October 29, 2024

**Re: Response to Technical Comments – SPC Application D07-12-24-0087; 2900 Brian Coburn Blvd./119 Ryan Reynolds Way**

13. Section 4.4 Access Design:

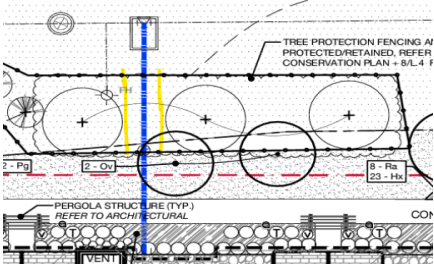
Restricting the proposed Brian Coburn Boulevard access to right-in / right-out (as identified in the 2021 TIA) is supported. However, the use of a 'pork chop' island results in large access corner radii, which supports high turning speeds in and out of the access and could be hazardous to future pedestrian and cycling facilities on the south side of Brian Coburn Boulevard. It is therefore recommended that the access be restricted to right-in / right-out by extending the existing median on Brian Coburn Boulevard further east, across the access. The 'pork chop' island can then be removed from the design and the access radii reduced. The reduction in corner radii may also allow the development to meet the TAC Geometric Design Guide recommendations for access clear throat length.

The proposed pork chop island has been shown on the Site Plan for several submissions through the pre-consultation process and has not been commented on to date. While the proposed pork chop island has a large radius, the channelization and narrow access throat width within the site (6.7m) will assist in reducing vehicle speeds. Further, the MUP can be designed at the back of the ROW where vehicles entering the site will have clear sight lines and the ability to stop off-road within the pork chop area. No changes to the pork chop design are proposed as part of this application.

A new median along Brian Coburn Boulevard would require RMA approval and is anticipated to result in significant additional costs to the proponent compared to the previously proposed pork chop island. As the new median is being requested due to the MUP extension project, if pursued by the City, the costs associated with the design and construction of a new median should be funded by the City as part of the MUP extension project.
